FIELD WORK VARIANCE

Project Name/Number	140705	CTO/WAD	
Applicable Document	KAFB Vadose Zone Investigation Work Plan Part 1: Field Investigation Activities Bulk Fuels Facility Spill Solid Waste Management Units ST-106 and SS-111	Date	January 26, 2011

Field Work Variance No. KAFB-FWV-2

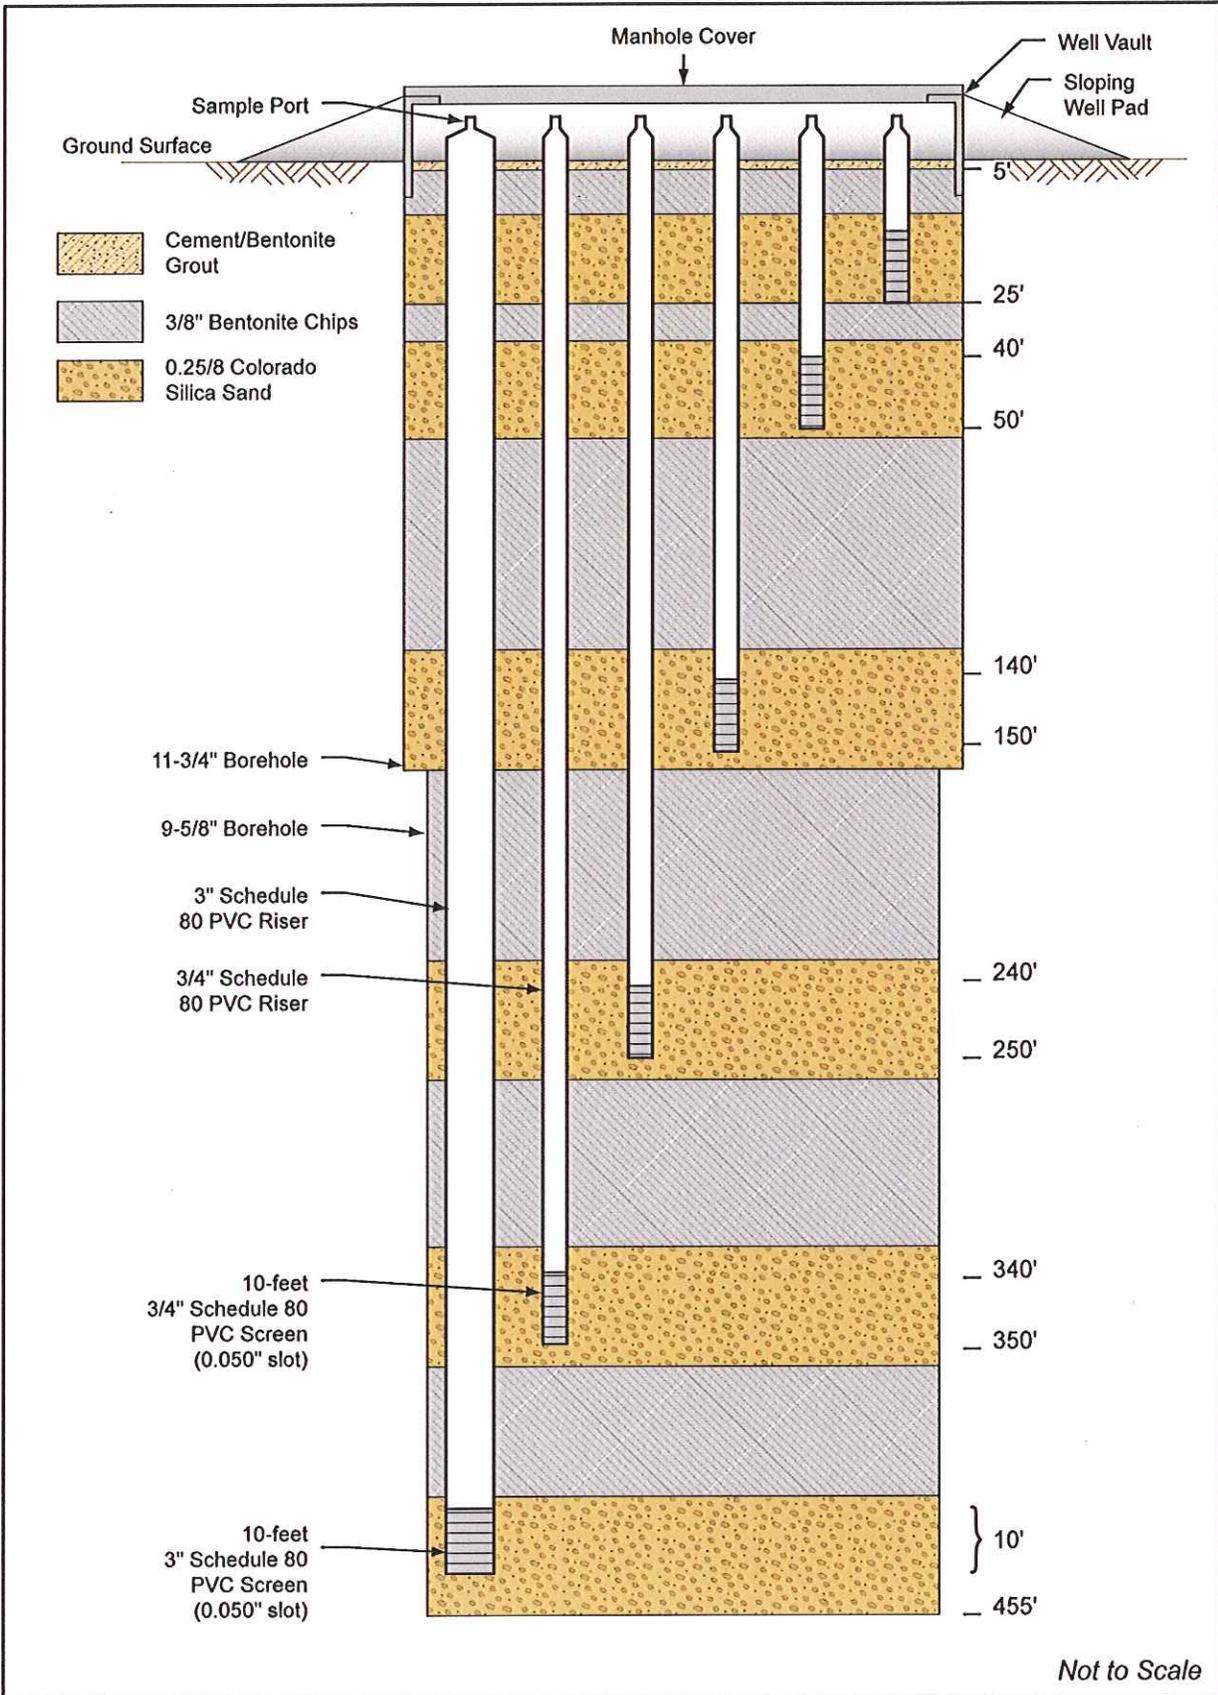
Soil vapor monitoring (SVM) well drilling and well completion specifications procedures have been changed due to regulator direction and site specific geologic conditions.

- Work Plan Section 5.2.11, replace "one 2-inch diameter, schedule 80 PVC" with "one 3-inch diameter, schedule 80 PVC"
- Work Plan Section 5.2.11, replace "engineered filter 8/10 graded pack" with "engineered filter 0.25"/8 graded pack"
- Work Plan Section 5.2.11, replace "The filter pack will be slurried with clean potable water and tremied into place..." with "The filter pack will tremied into place through the drive casing dry..."
- Work Plan Section 5.2.11, replace "After the last lift has hydrated for 2-hours, a high solids bentonite grout will be emplaced by tremie pipe to 1 ft below the next higher point" with "Bentonite chips will be tremied through the drive casing above the filter pack to 1 ft below the next higher point"

A revised construction diagram is attached.
